# Final Drainage Report

**Jackson Ranch  
Filing No. 4**

**April 18, 2017**

Add: "PCD Project No. SF-17-016"

Soil Map—El Paso County Area, Colorado  
(Jackson Ranch)

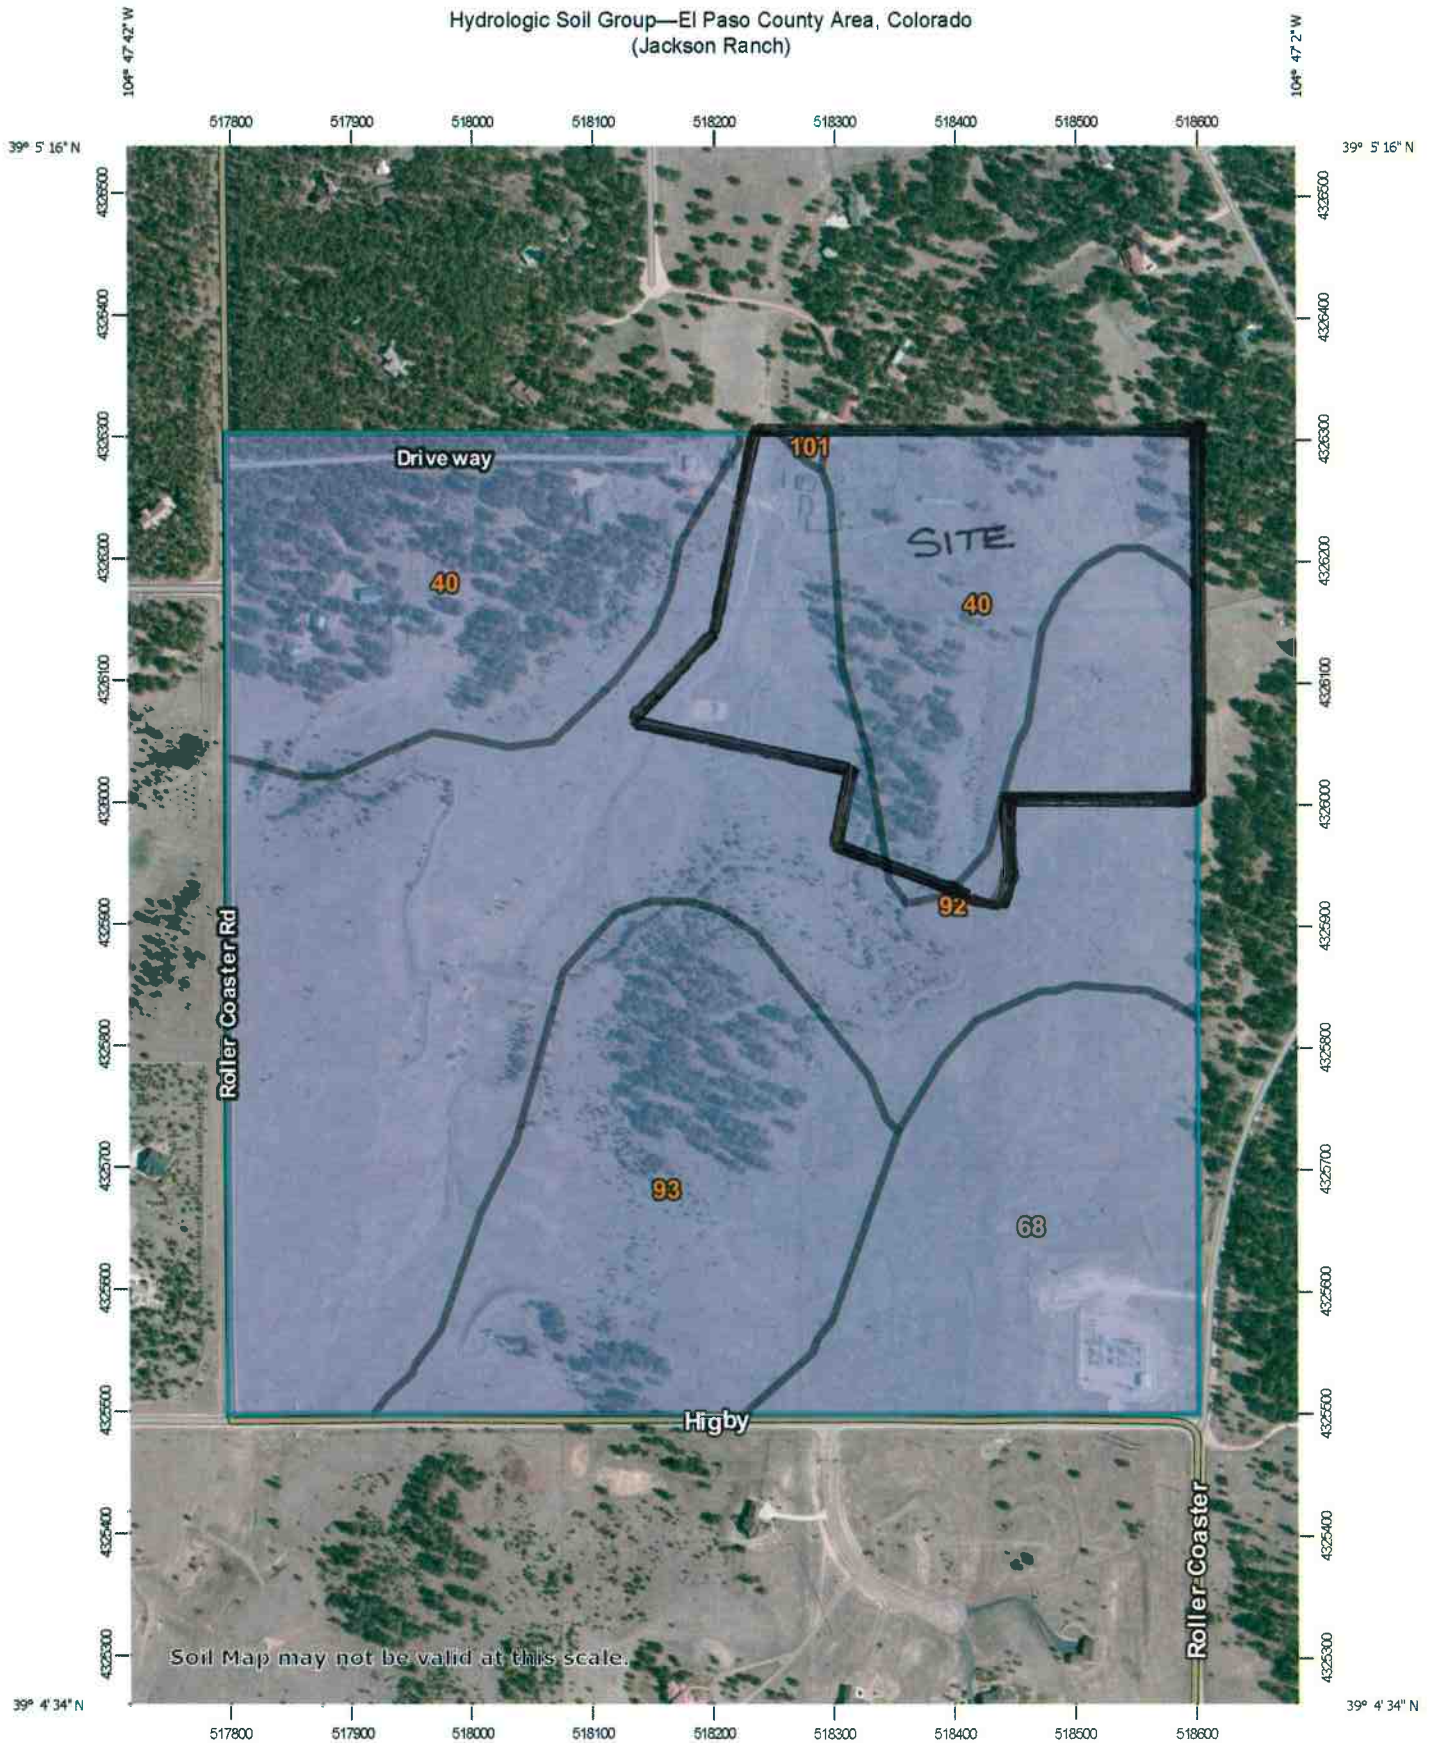
Revise to map unit 92 as shown  
on the NRCS soils map.

MVE PROJECT 61073  
 MVE DRAWING PP-DR-MapF4

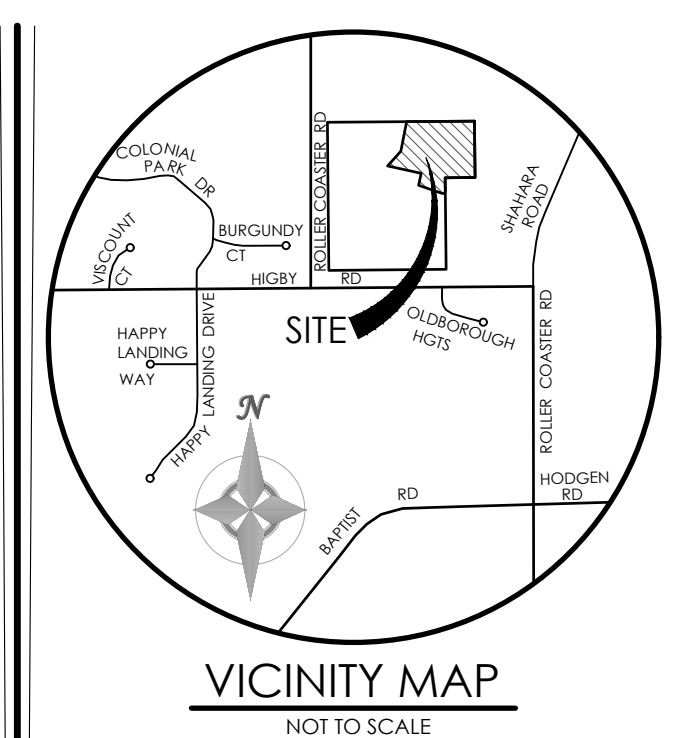
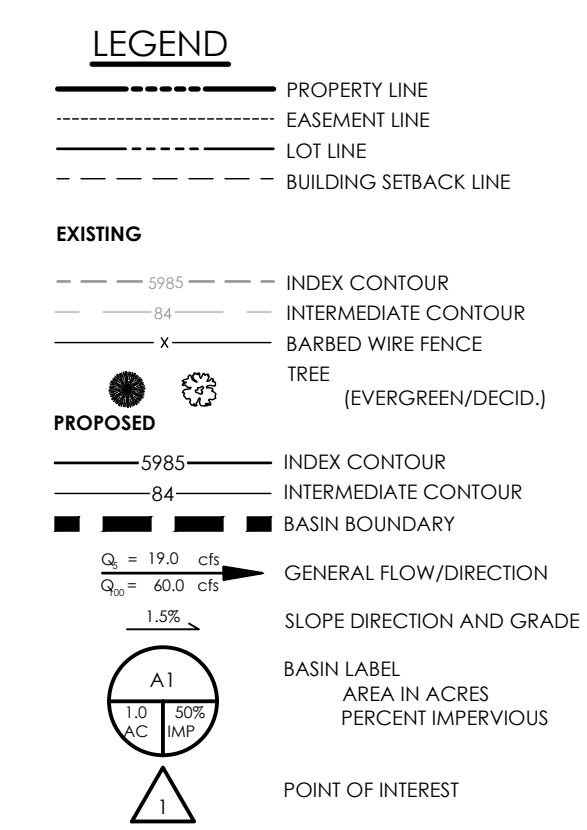
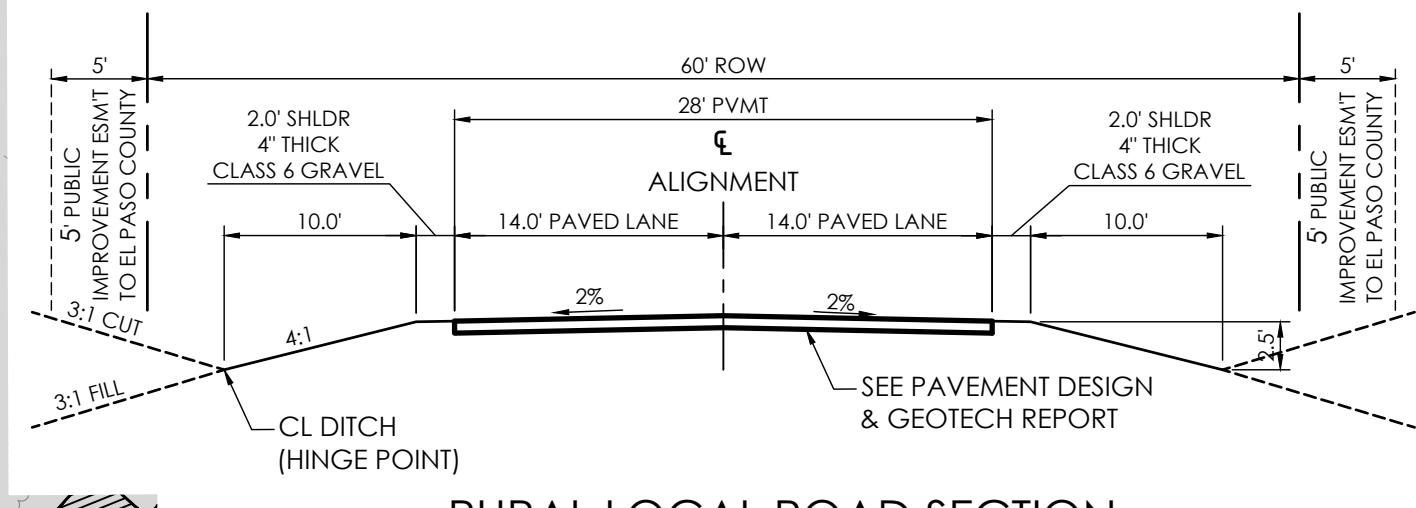
The combined flow runoff calculation worksheet needs to show how this value was calculated. With no proposed detention and an increase in imperviousness this should be greater than the existing condition. Comment also applies to the existing condition.
